CITY CENTER OFFICE PLAZA JSP21-06

Consideration of the request of City Center Office Plaza, LLC for approval of the Preliminary Site Plan and Stormwater Management Plan. The subject property contains 1.25 acres and is in Section 15, on the west side of Flint Street, south of Grand River Avenue. The applicant is proposing a three-story office building with a bank on the first floor and general office on the upper floors (15,300 square feet total). The site plan includes a two-lane drive-through for the bank use on the south side of the building.

PLANNING REVIEW

Review Date: March 14, 2022
Review Type: Revised Preliminary Site Plan
Project Name: JSP21-06 City Center Office Plaza
Location: Parcels 22-15-477-011, 22-15-477-012
Plan Date: February 6, 2022
Prepared by: Lindsay Bell, AICP, Senior Planner
E-mail: lbell@cityofnovi.org; **Phone:** (248) 347-0484

L-1

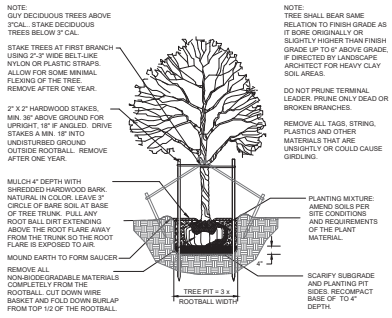
3. Parking Screening (Sec. 3.27.1.D): Surface parking areas must be screened by either a 2.5 ft. brick wall or a semi-transparent screening or a landscaped berm from all public ROW. **The applicant has proposed a 2.5 feet brick wall, but it does not adequately screen the full parking lot. If the plan is not revised to meet the code, a landscape waiver will be required. Landscape review suggests hedges could be provided between the wall sections to provide additional screening to meet the intent of the ordinance.**

side of the loading area, and the building screens to the west. **Juniper plantings are now proposed on the east side of the loading area. Please indicate the height of the plantings to confirm they will be tall enough to effectively screen the area from Flint Street.**

The PSP does not specify proposed impacts to the regulated wetland area. However, sheet L-1, *Landscape Plan*, depicts the placement of sod and of six trees, as well as a portion of the proposed parking lot, within 25 feet of the Walled Lake Branch. The City of Novi regulates both wetlands and the associated 25-foot natural resources setback buffer. The 25-foot limit is measured as horizontal feet, regardless of grade change. The setback buffer may be enhanced with appropriate plantings (e.g. native trees, shrubs, perennials), but the placement of non-native plants such as lawn grass or construction of paved areas will require authorization to encroach on the wetland buffer.
